Project Title: Tommy 210gal Tanks

- Replaces 400 Gallon tanks and 1000L tanks.
- The new tanks provide a significant cost savings that is passed on to Franchise Partners.
- 2 tanks will be plumbed together on site increasing the overall capacity of Reject and RO water.
- We have included a stand for these units for sites without a mezzanine – P-W-0110

Product Image:

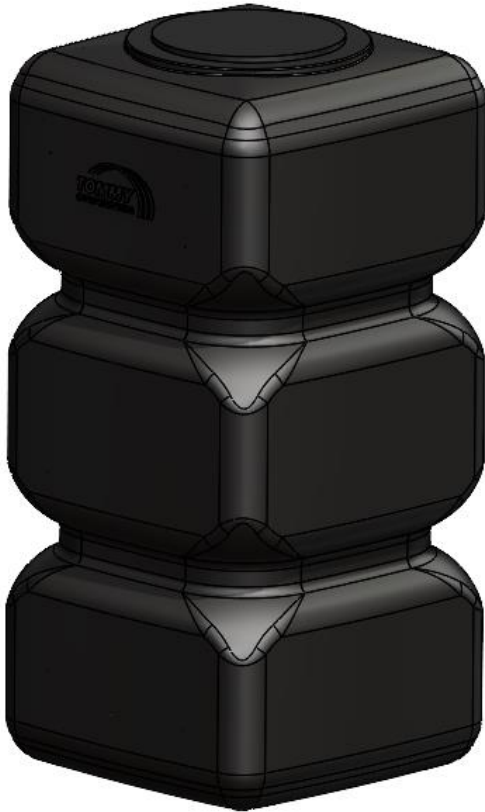
The new 210 gallon tanks are more cost-effective than the previous 400 gallon tanks, as well as the 1000L tanks. The new tanks offer higher capacity (when tied together) than the previous 400 gallon tanks. The color agent is compounded with the resin meaning that it blocks UV light much better than previous tanks. This will help prevent algae growth in the tanks. The tanks will be located in the mezzanine - if there is not a mezzanine, we offer a stand (P-W-0110) to put the tanks on, to feed pumps with gravity, rather than requiring a supply/booster pump: NOTE: Tank stands will need to be placed in close proximity to the AIO and RO for this to work. 4 total tanks take up the same footprint of the 2 400 gallon tanks and will utilize the same drain pans. These tanks also can be used with water treatment center OR Tommy RO. If using a pureclean RO, there is a separate assembly that must be used (See Appendix A for details).
